Northern Link Road Tunnel Project

## **Application for Project Change**

October 2010

Figure 1: General Alignment– Changed Project

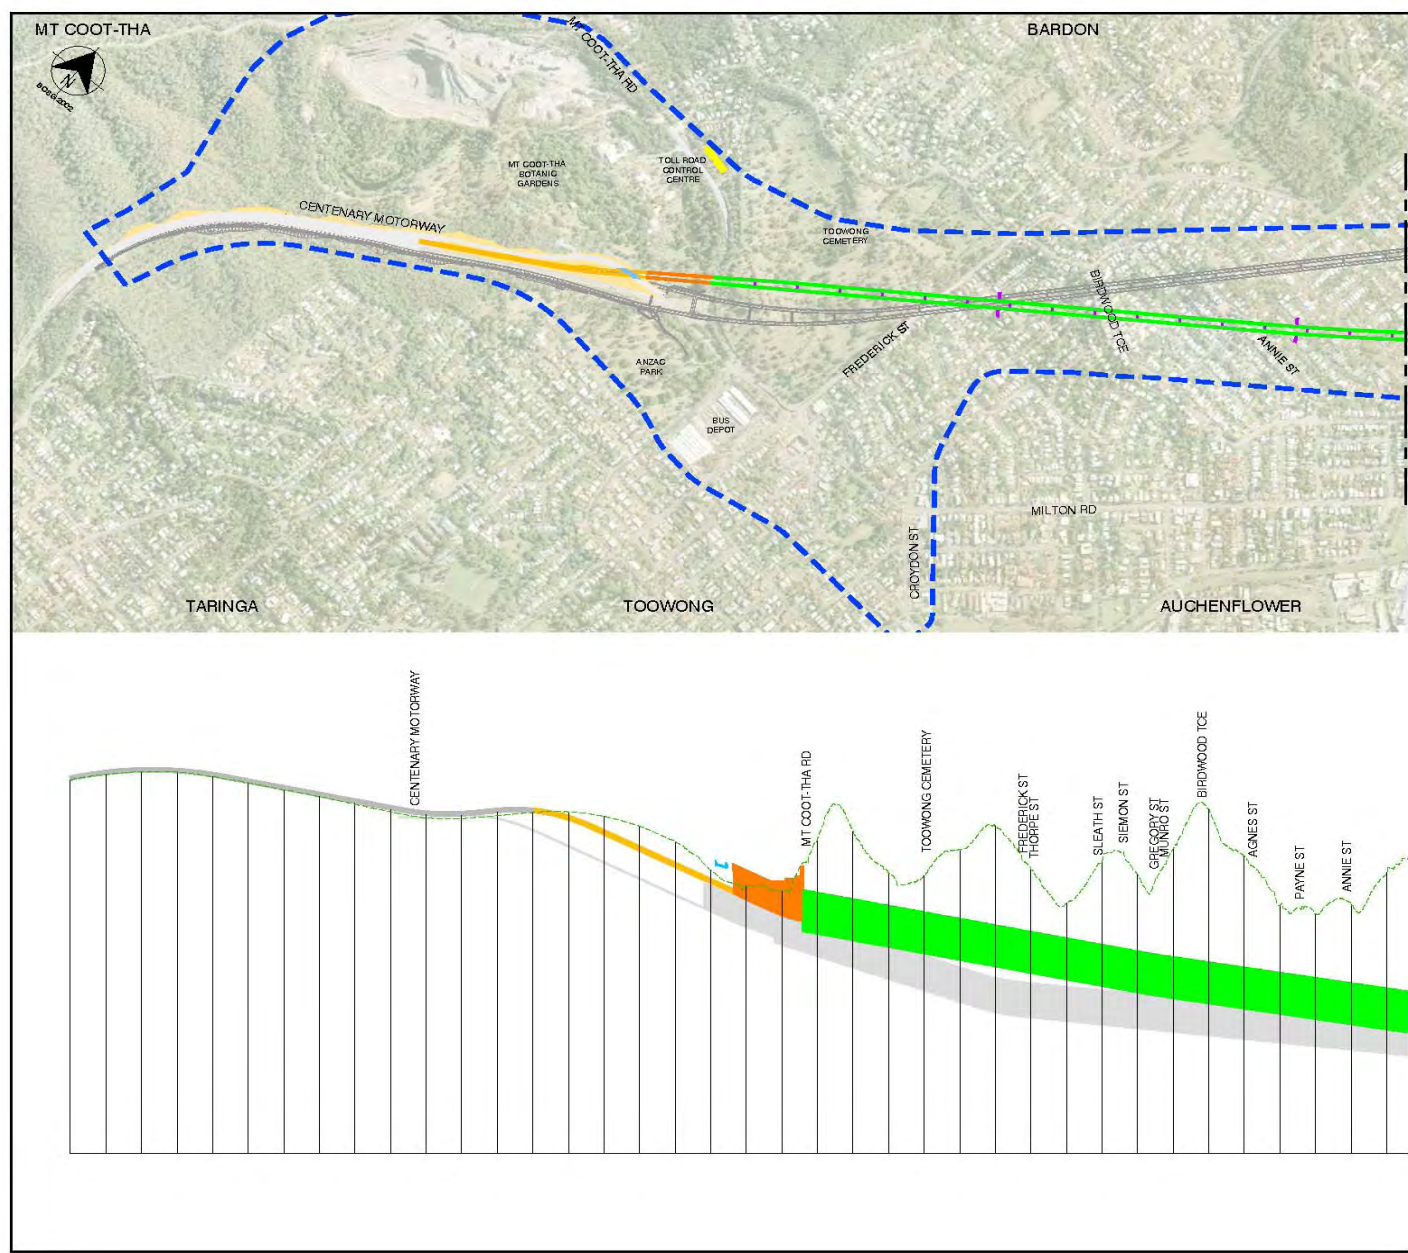
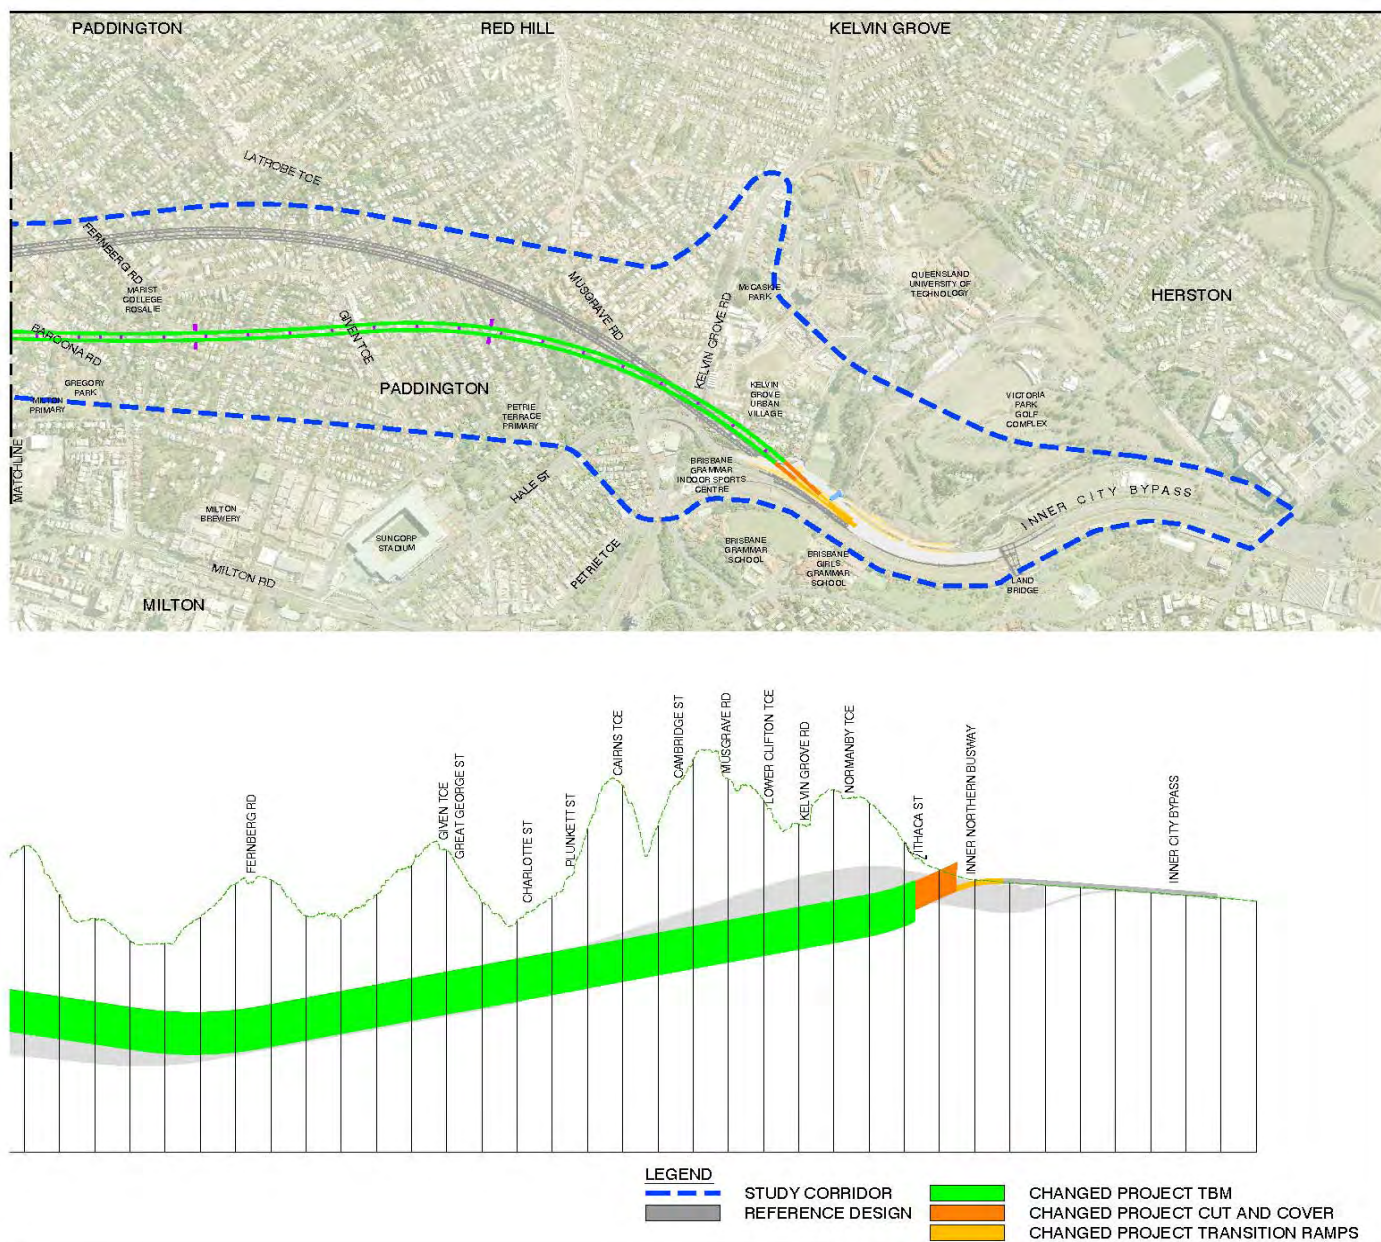
**Figure 1** shows the general alignment of the Changed Project in comparison with the Reference Design.

- Horizontal Alignment – the main alignment between the connections would differ from the Reference Project by commencing at the western side of Mt Coot-tha Road approximately 100m north of the Reference Design alignment. The main alignment would then pass under the Toowong Cemetery, in a straighter route up to 300m south of the Reference Design to connect with the ICB on the southern side of Normanby Terrace. The connection would be near to the location indicated for the Reference Design. The proposed change in the main alignment would provide a more direct route between the connections. There would be a reduction in the number of properties affected by acquisition of volumetric title;

- Vertical Alignment - The vertical alignment of the main alignment for the Changed Project would be shallower for most of the route apart from the section from Carins Terrace east. This is due to the change in the horizontal alignment and ground surface levels at those locations and design changes to optimise tunnel gradients;

Figure 2-2: Changed Project Horizontal Alignment

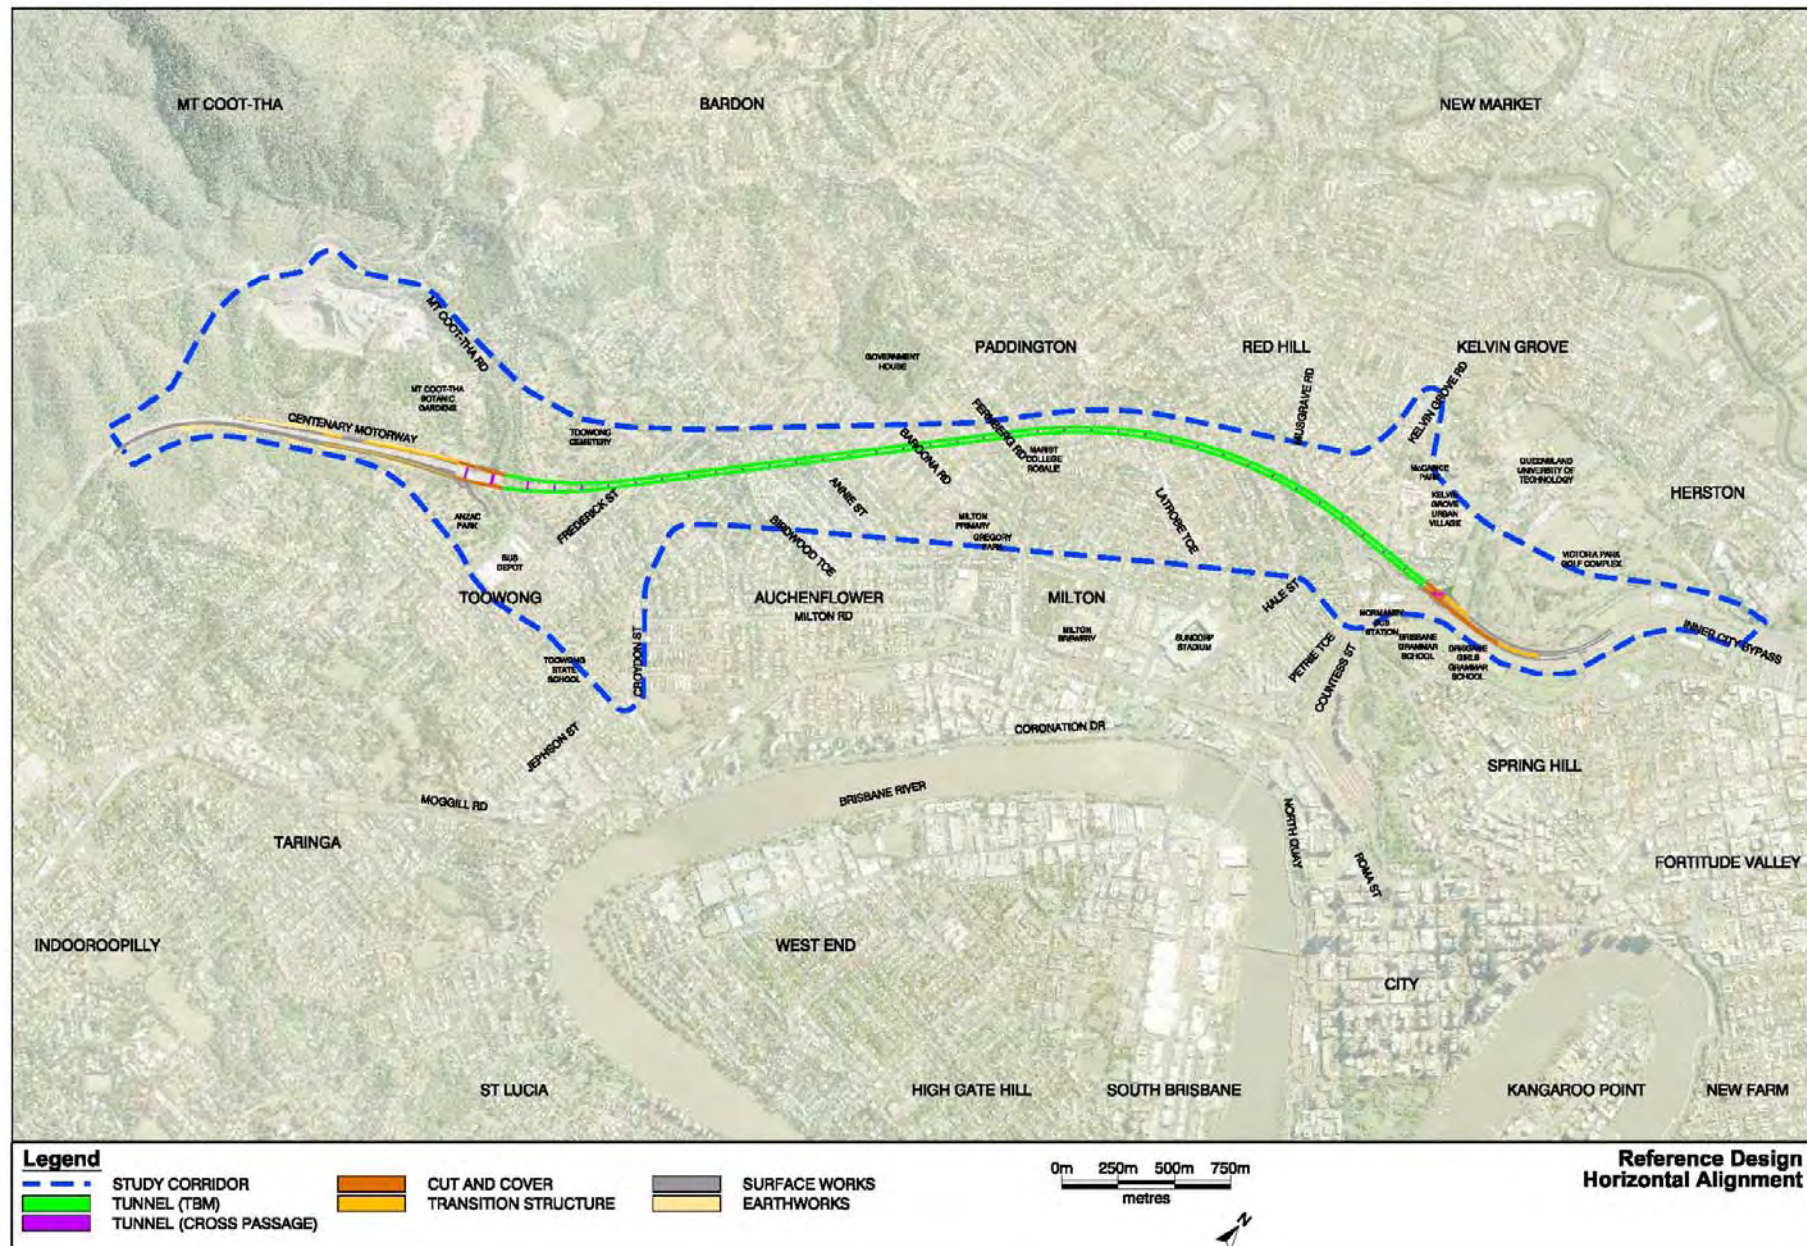
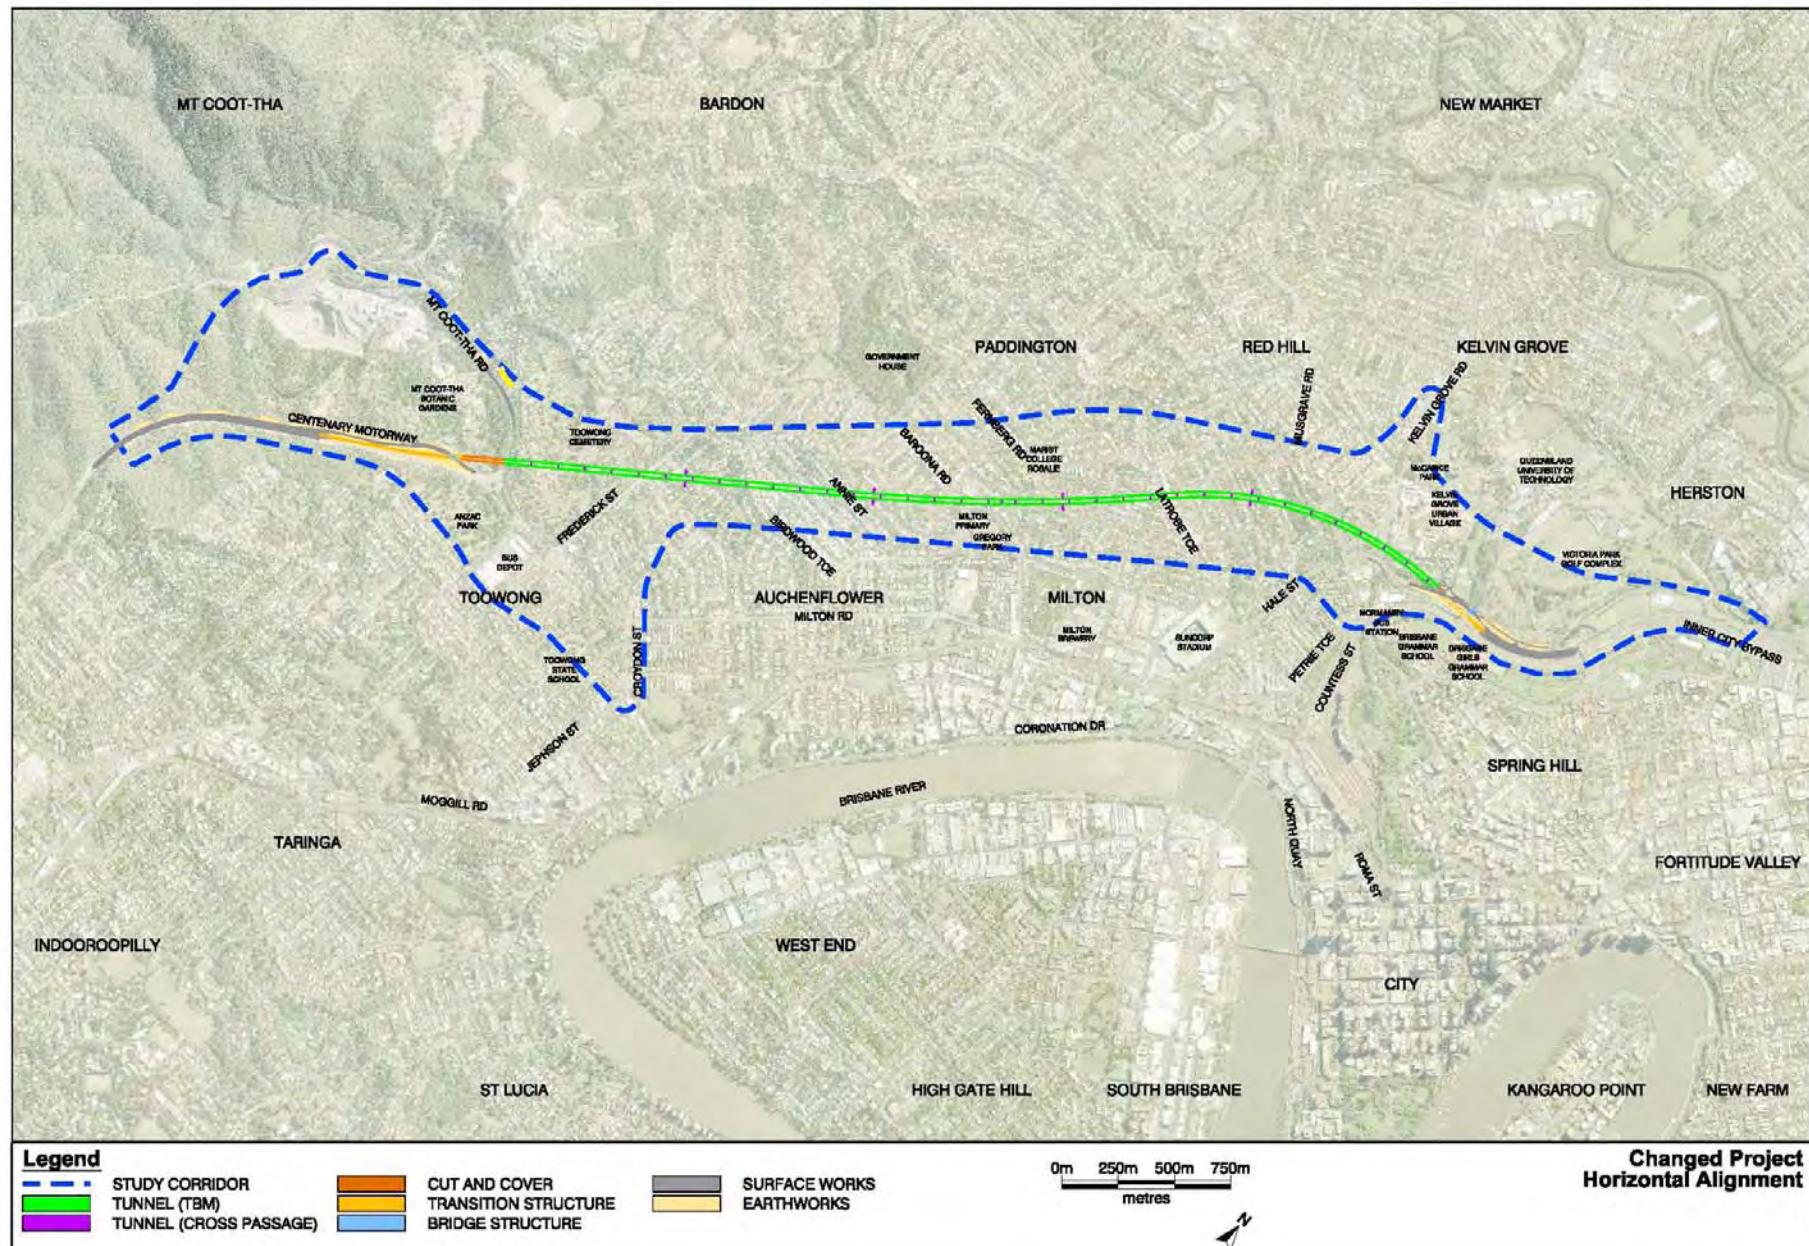
Design Element	Description of the Reference Design (RD)	Description of the proposed Change	Reason(s) for Change
<b>TBM Tunnel Alignment</b>			
Horizontal Alignment	From south-west corner of Toowong Cemetery in an arc along the northern section of the Study Area to surface on the southern side of Normanby Terrace residences west of Victoria Park Road.  Refer to <b>Figure 2-1</b> above and Supplementary Report Volume 2 Planning Layout Drawings <sup>1</sup> .	From the western side of Mt Coot-tha Road and 100m north of the RD alignment under the Toowong Cemetery in a straighter alignment through the centre of the Study corridor up to 300m south of the RD alignment to land on the southern side of Normanby Terrace residences.  Refer <b>Figure 2-17 to Figure 2-20</b>	Enables both TBMs to be launched off-line within the construction worksite and outside of existing traffic areas.  Avoids construction through Mt Coot-tha Road and the roundabout. Provides improved grades for the associated cut and cover and transition structures to the Centenary Motorway.  Provides a more direct alignment while maintaining suitable geology with some reduction in TBM length (westbound TBM -60m and eastbound TBM – 30m) and private property volumetric requirements.

The principal change to the Reference Design is the proposed realignment of the main tunnels between the connections with the Centenary Motorway and the ICB. The main tunnel alignments would be straighter and shallower to create a more direct, safer and more efficient motorway-standard link between the Centenary Motorway and the ICB. These changed alignments are shown in **Figure 2-1** and **Figure 2-2**.
